Riley Purgatory Bluff Creek Watershed District Permit Application Review

Permit No: 2022-070

Project: Schutrop Addition: Proposed redevelopment of an existing single-family home parcel into two single-family residential lots with homes. The existing home will remain, with construction of a new home on the second lot. Proposed stormwater feature includes one rain garden.

EROSION CONTROL

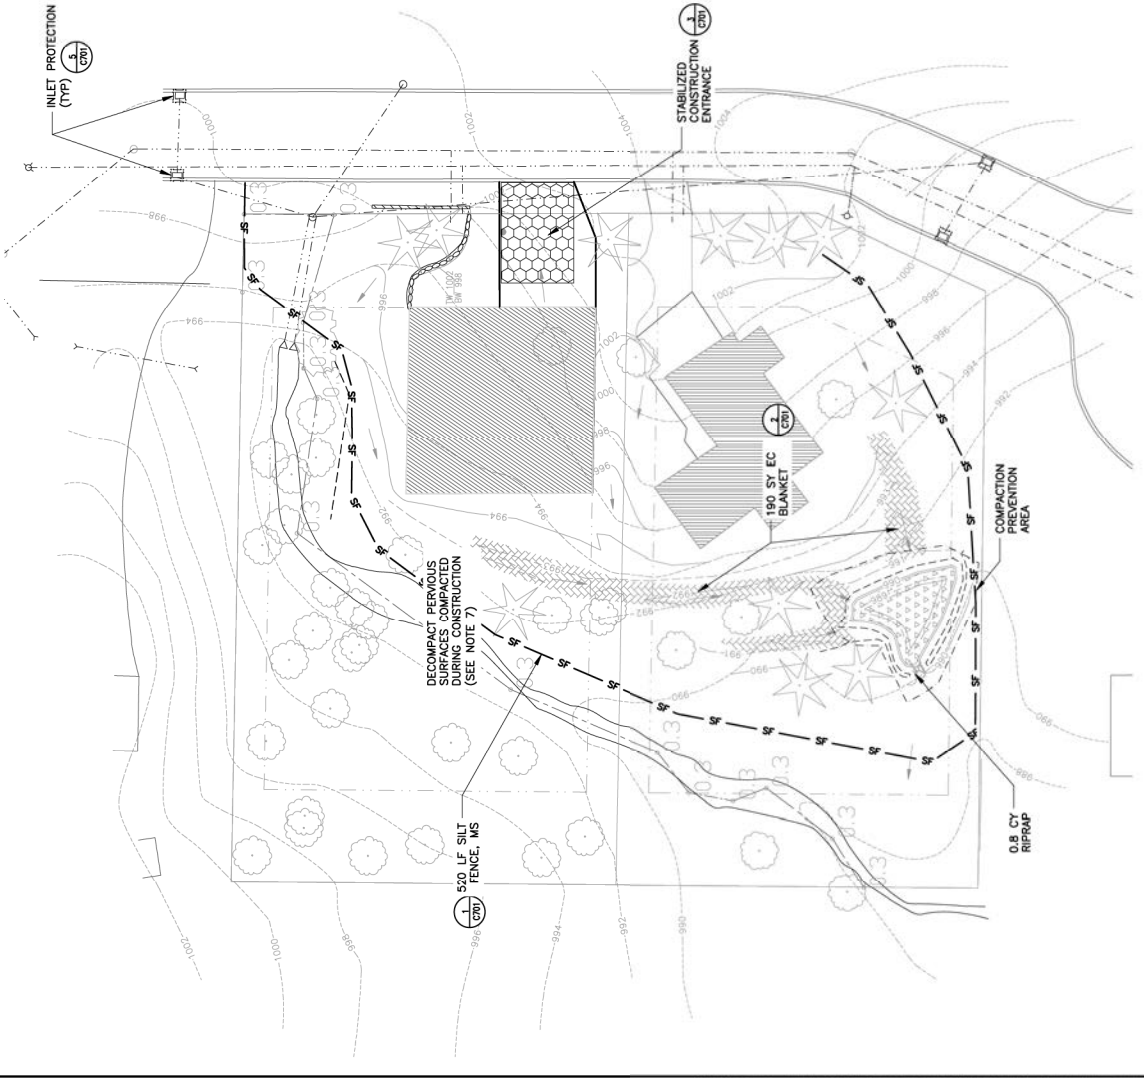
Because the project will involve 0.59 acres of land-disturbing activity, the project must conform to the requirements in the RPBCWD Erosion and Sediment Control rule (Rule C, Subsection 2.1). The erosion control plan prepared by Civil Methods, Inc. includes installation of perimeter control (silt fence or sediment control logs), a stabilized rock construction entrance, inlet protection, daily inspection, placement of a minimum of 6 inches of topsoil (at 5% organic matter), decompaction of areas compacted during construction, and retention of native topsoil onsite to the greatest extent possible. To conform to RPBCWD Rule C requirements, the following revisions are needed:

- C1. The Applicant must provide the name, address and phone number of the individual who will remain liable to the District for performance under this rule and maintenance of erosion and sediment-control measures from the time the permitted activities commence until vegetative cover is established.
